ADDENDUM # 1

November 5, 2021

**Bataan Lift Station Renovation
Bid No. 2021-09**

Bohannon Huston Inc.

BHI PROJECT NO.	20210255	DWG NO.	E-400-R1	SHEET OF	25	29
-----------------	----------	---------	----------	----------	----	----

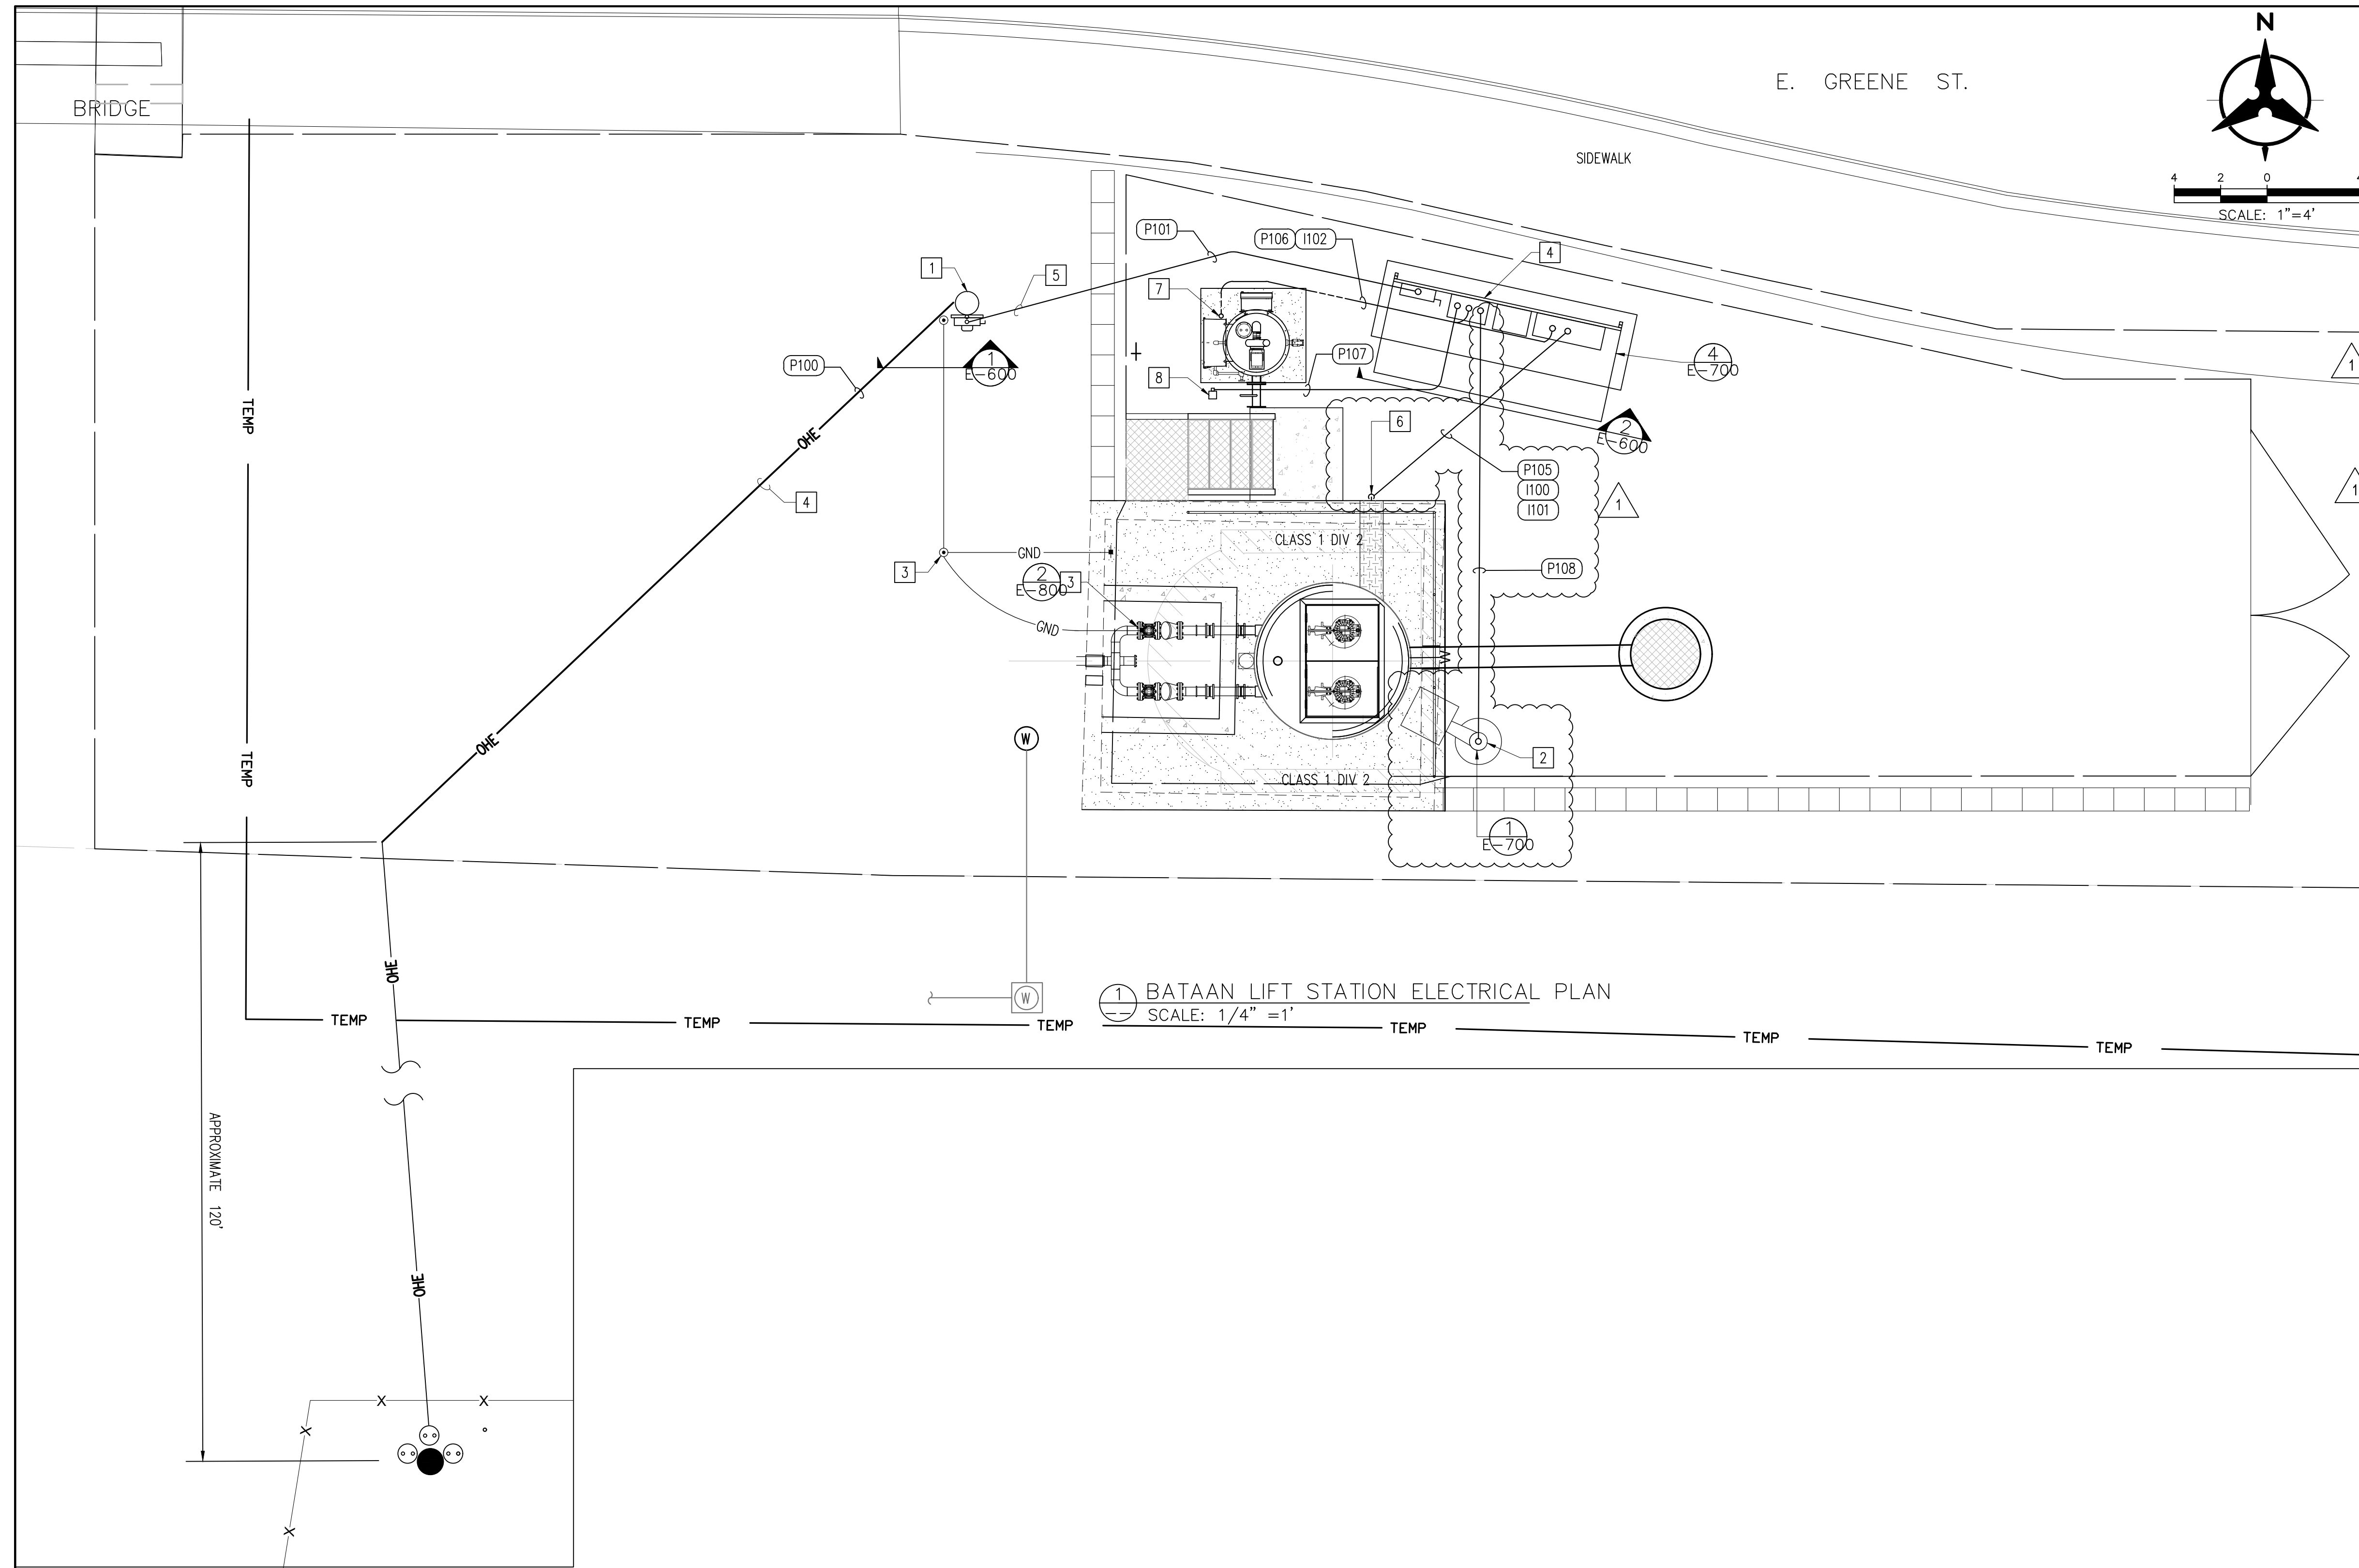
4. **Drawing C-1400-R1**: Revised manhole details and force main details.
5. **Drawing E-400-R1**: Deleted submersible cable junction box and associated raised concrete pad; Moved location of pole mount light fixture adjacent to southeast corner of wet well structure; Lengthened depth of shade structure; Revised keyed note 4.

BHI PROJECT NO.	20210255	DWG NO.	E-500-R1	SHEET OF	26	29
-----------------	----------	---------	----------	----------	----	----

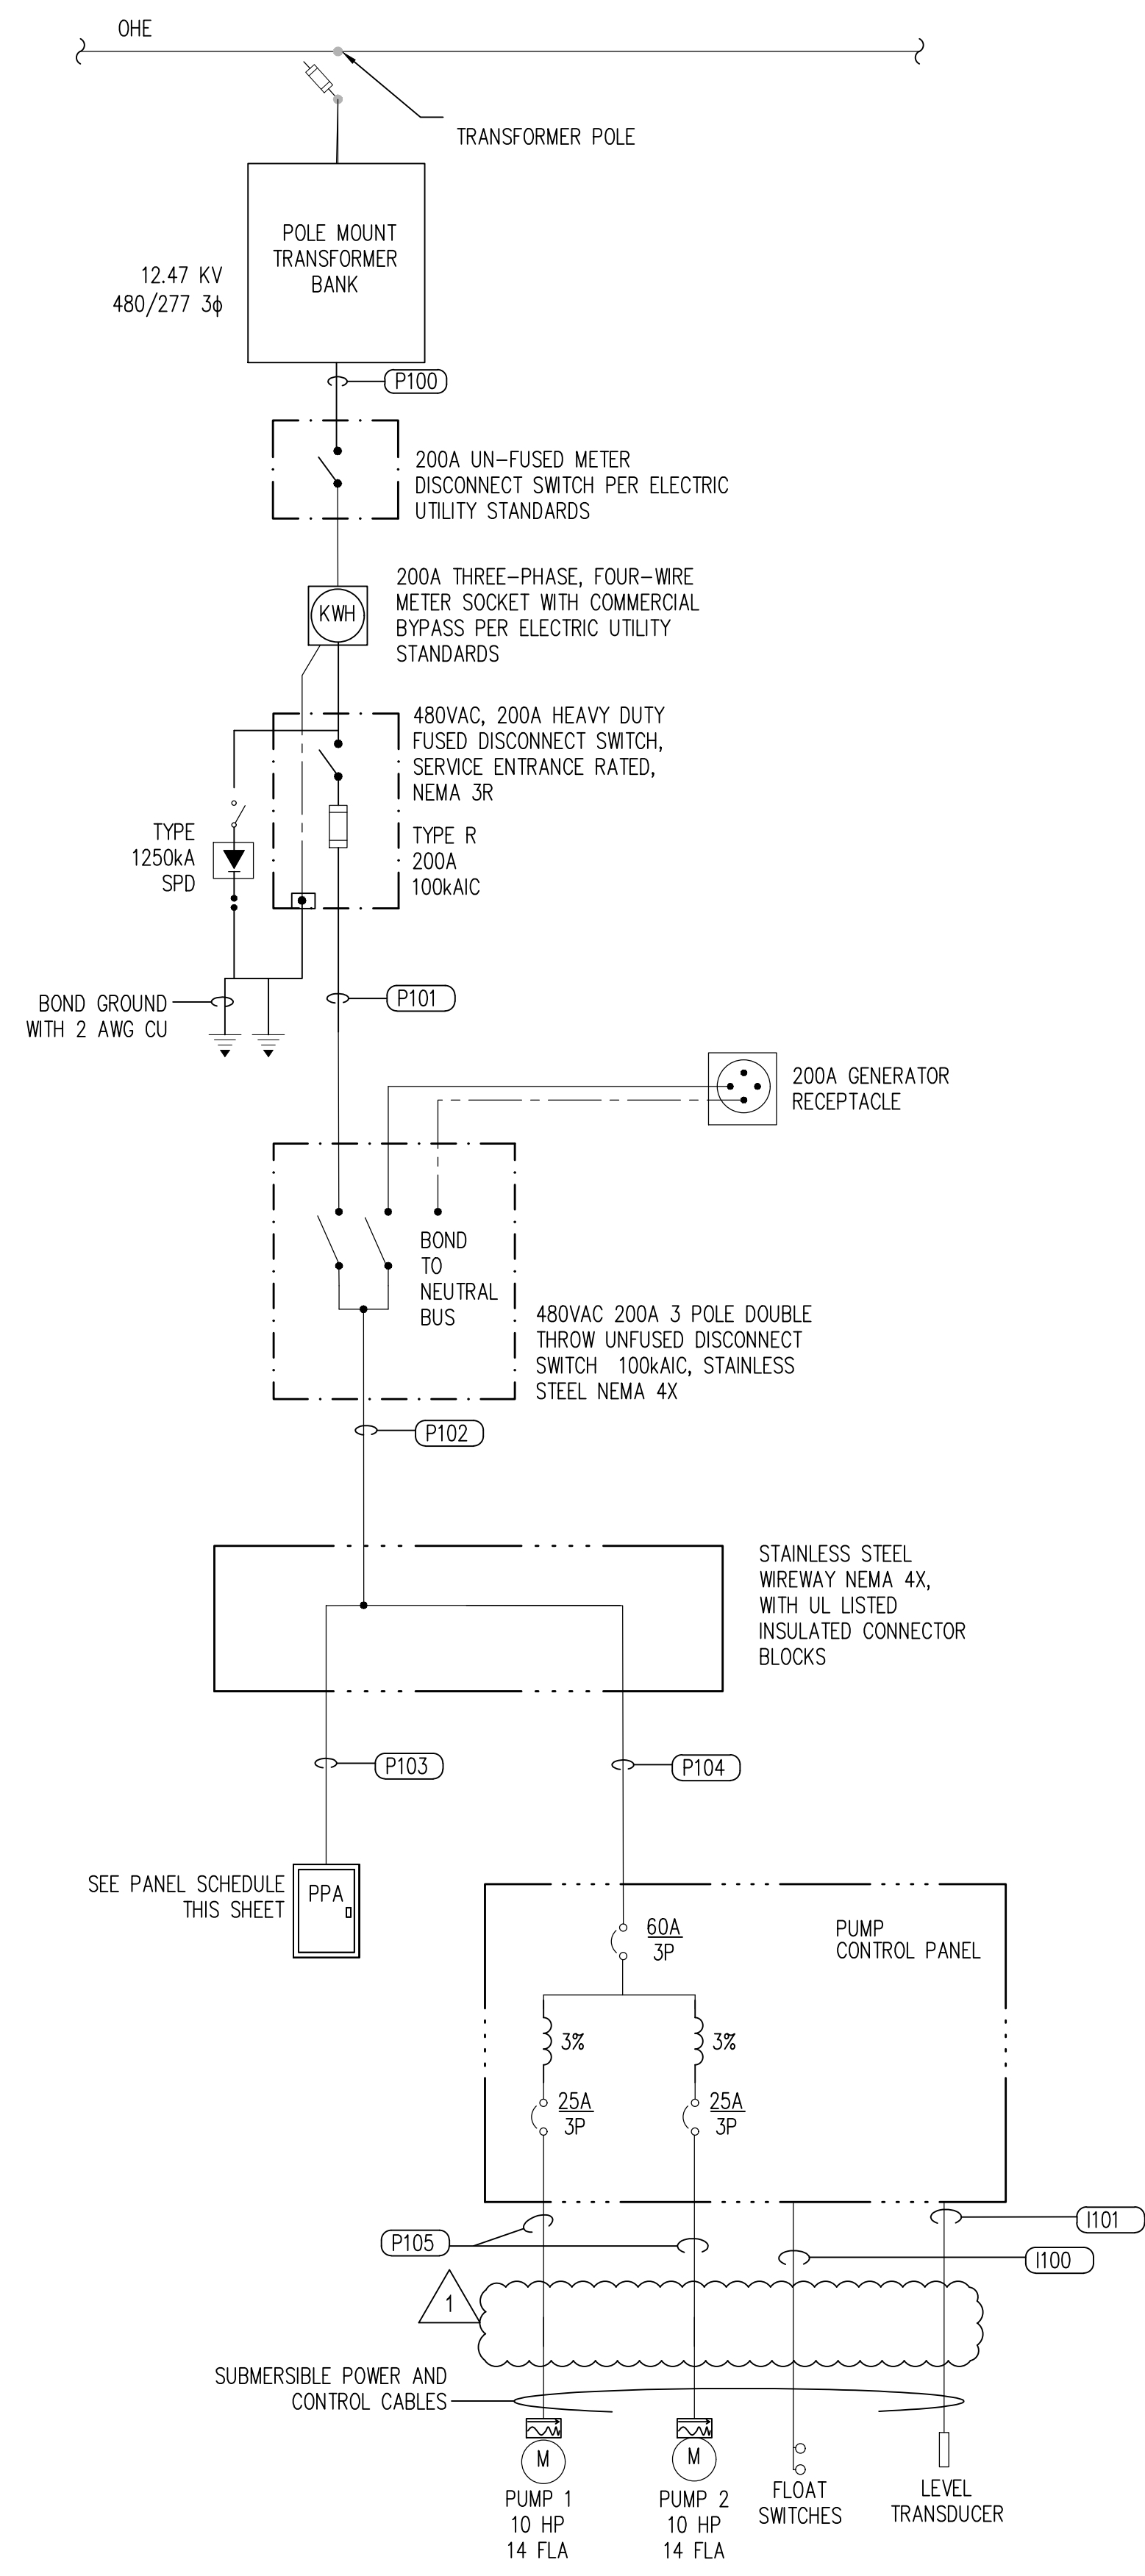
6. **Drawing E-500-R1**: Deleted submersible cable junction box from one line diagram.
7. **Drawing E-600-R1**: Revised lift station wet well detail to show conduit routing to control panel and deletion of submersible cable junction box; Revised equipment rack detail to show addition of conduit seals entering control panel.
